Relevant Information for Central Sydney Planning Committee

FILE: D/2022/495 **DATE:** 17 August 2023

SUBJECT: Information Relevant To Item 5 – Development Application: 133-141 Liverpool Street, Sydney – D/2022/495

Revised Colonnade Drawings

GROUND FLOOR
Scale: 1:100

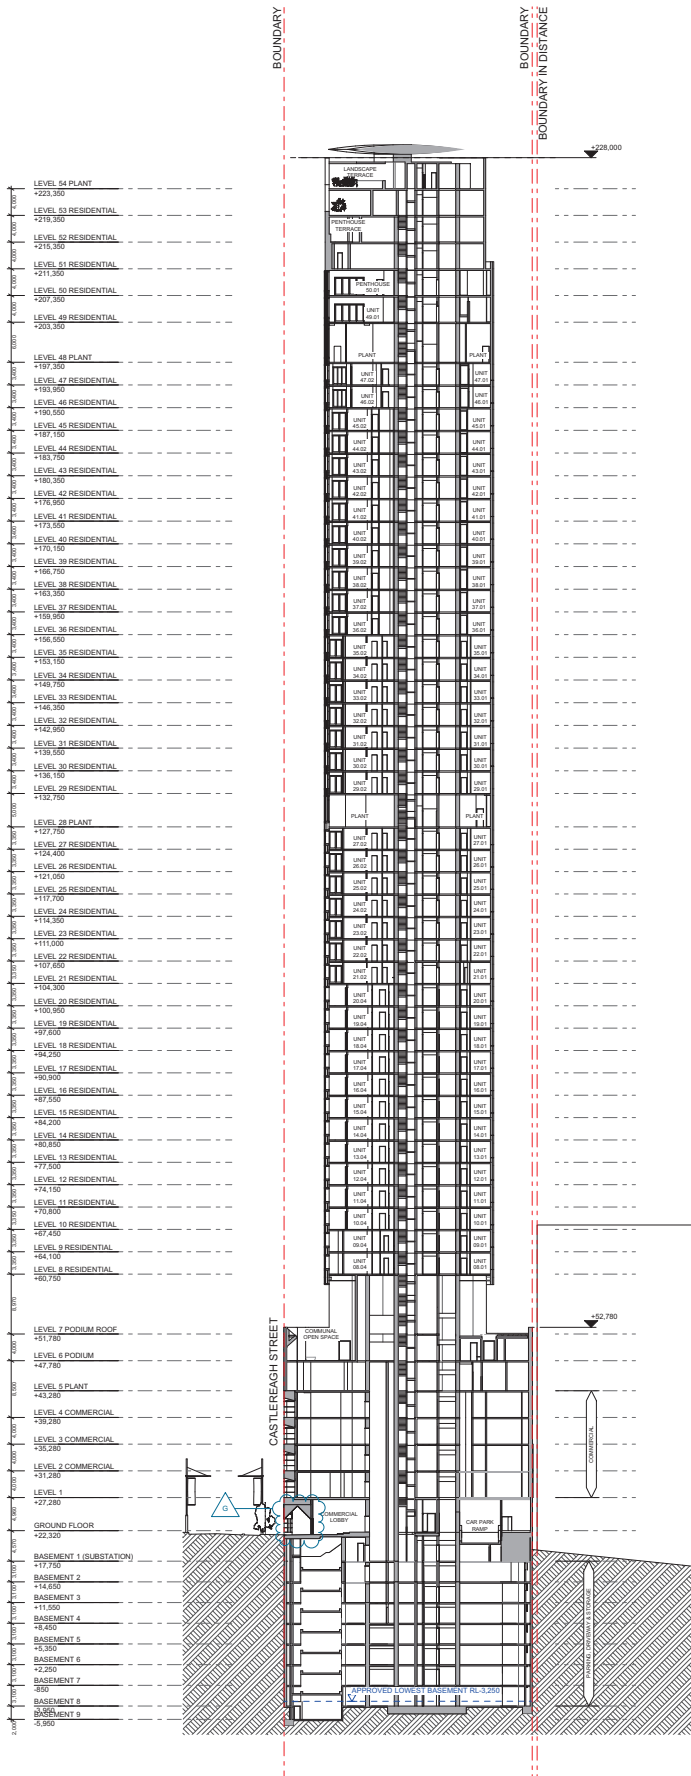
As a result of this request, on 15 August 2023, the applicant on their own volition submitted an amended colonnade design to respond to feedback and to address the relevant controls of the Sydney Development Control Plan 2012 (DCP) for colonnade design and addressing the public domain. A revised single storey colonnade is proposed which retains the rhythm of triangular structural columns, while reducing the width of the columns and introducing a new opening within the column to increase pedestrian amenity and safety within the colonnade.

- (a) Continuous for the entire street block on Castlereagh Street. A stepped internal soffit is proposed to the colonnade with an approximate 4.2m height at the peak and 2.4m at the base, which terminates at the driveway to allow for large vehicles to enter the site on Castlereagh Street. This remains unchanged from the previous proposal.

- (b) Designed with finely proportioned triangular columns, creating an appropriately proportioned vertical form at the Castlereagh Street boundary. The reduced width of the columns under this proposal retains and enhances the finely proportioned verticality of the colonnade.

- (c) The colonnade provides a high level of visual and physical access to the retail shopfront at the corner of Castlereagh Street and Liverpool Street with the inclusion of a 3m x 3m splay, which is improved under the proposal by the reduction in width of the column, and through the introduction of a new opening within the column to increase visual access within the colonnade.

It is recommended that the revised colonnade design be supported and Condition (1) of the recommended conditions be amended to replace the relevant ground floor plan, elevation and section drawings with drawings that reflect the revised design.
